MC68302 Errata Revision C.1 (Masks 0F26E, 1F26E)

ERRATA

1. Interrupt Vectors in Slave Mode

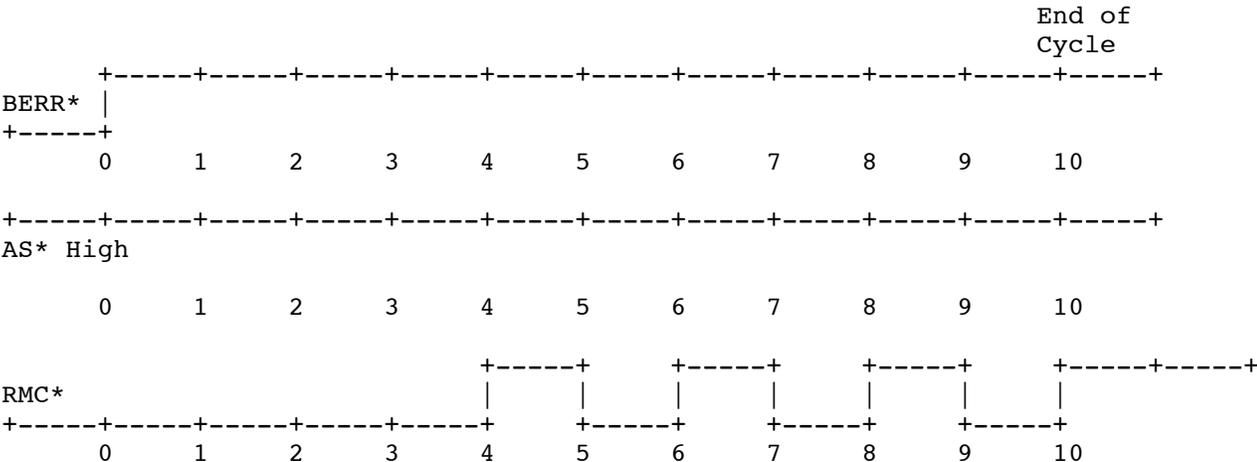
If the MC68302 is used in slave mode AND and an external asynchronous master is used AND the external master has not performed an internal read cycle since the previous IACK cycle, then during the current IACK cycle, the 302 will drive the previous interrupt vector and the IPR and ISR registers will not be updated.

- Option 1)** The user should perform an internal read cycle (i.e. read the IPR or ISR or any other internal register) during the Interrupt routine.
- Option 2)** Eliminate One of the Possible Causes - The user may implement a workaround by eliminating one of the conditions listed above, that can cause the bug.
